Initial peer review of

Air Quality Analysis of NSW Tunnel Data — DRAFT, 7 Nov 2024

Figure A Wind roses from three air quality monitoring sites across Sydney, from Hibberd (2019)

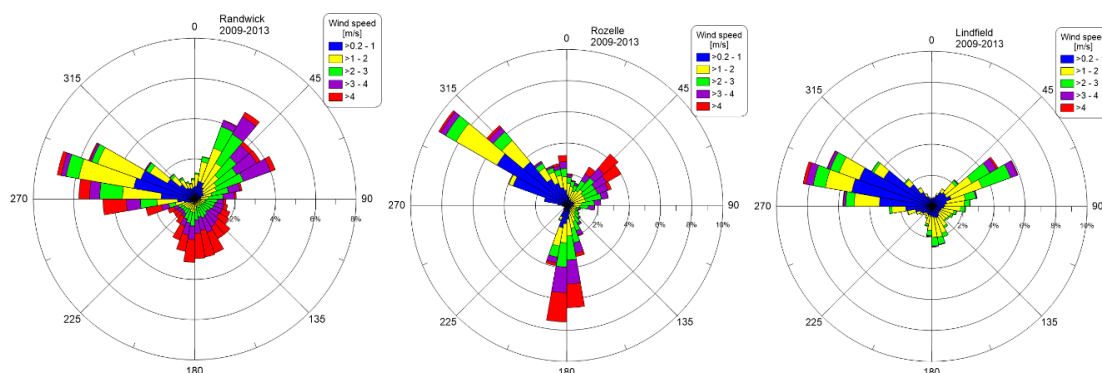
2. *Choice of meteorological data.* Section 1.2 discusses the reasons for using the meteorological data from Sydney International Airport in all the analyses. It mentions that local on-site data were/could also be used and that “similar conclusions would be drawn using local meteorological data at most sites”. Were there sites where the conclusions were different? As an indication of differences across the Sydney basin, Figure A shows wind roses from three air quality monitoring sites – Randwick (~5 km from the airport), Rozelle (~10 km), and Lindfield (~20 km). An important consideration is whether the wind directions at the airport are representative for sites up to 25 km away, e.g. NorthConnex. If not, then directional information from the polar plots could be misaligned with respect to local sources. Has this been taken into account in assessing the plots for possible tunnel vent signals?

7. *Wind directions averages.* Tables with the summary site information (Tables 1, 3, 4, 5, 6, 7) list the average wind direction for the meteorology used for analysing each site. This parameter should not be included in these tables. It is not an informative parameter for the analysis undertaken in this report because the wind rarely blows from the “average” direction. This is demonstrated by typical wind roses for the region shown in Figure A.

Figure B Polar plots of Jackson site data from Figures 3, 9, 11. The right-hand figure is Jackson-Wavell differences.

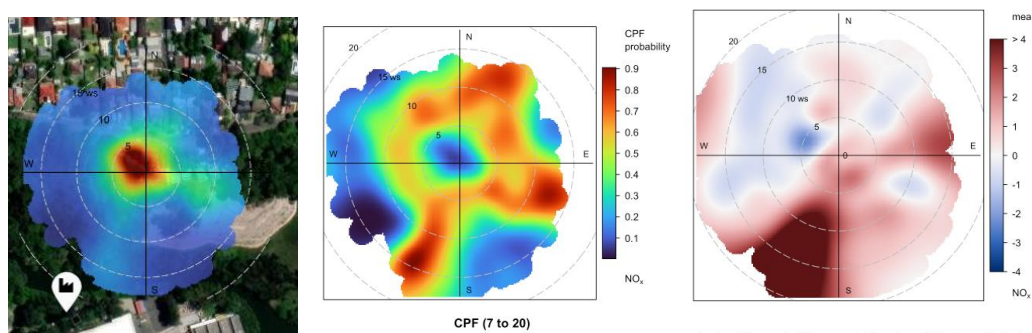
3. *More extensive use of conditional bivariate probability function (CBPF) plots like Figure 9.* Using the example of the Jackson site, Figure B shows that the basic polar plot of concentrations (left) only gives a hint of a tunnel vent signal. How well it stands out is quite sensitive to the colour scale used. In contrast, the middle and right-hand plots clearly show a signal. Uria-Tellaetxe and Carslaw (2014) discuss the sensitivity of CBPF plots and how different concentration ranges can be used to discriminate between potential sources. The right-hand plot shows the differences in concentration between Jackson and Wavell. It is only these difference polar plots that are shown in the rest of the report to assess the presence/absence of a tunnel vent signal. However, the ability of the CBPF plots to distinguish between surface and elevated sources could prove useful for the regions where the tunnel vents are located close to major road emissions. Whether or not they reveal contributions from the tunnel vents, the results would strengthen the conclusions from this report about the impacts of tunnel vents on nearby air quality and assist in setting an upper bound on the size of possible tunnel vent impacts in ambient monitoring data.

Figure C Extracts from the Report's Figure 3 for NO_x (left) and Figure 5 for CO (right)

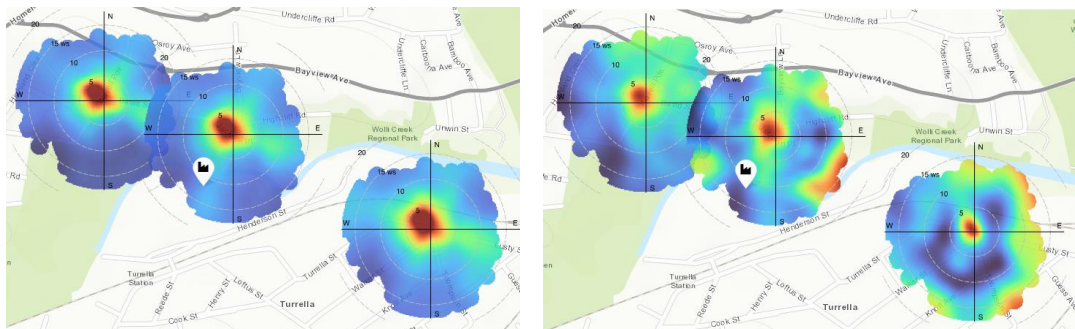
15. Last sentence before section 2.1 says that the polar plots for CO are “broadly similar” to those for NO_x and do not show clear directional impacts of the vent stacks. The plots are copied in Figure C below; some aspects look quite different. Please be more specific than “broadly similar”.
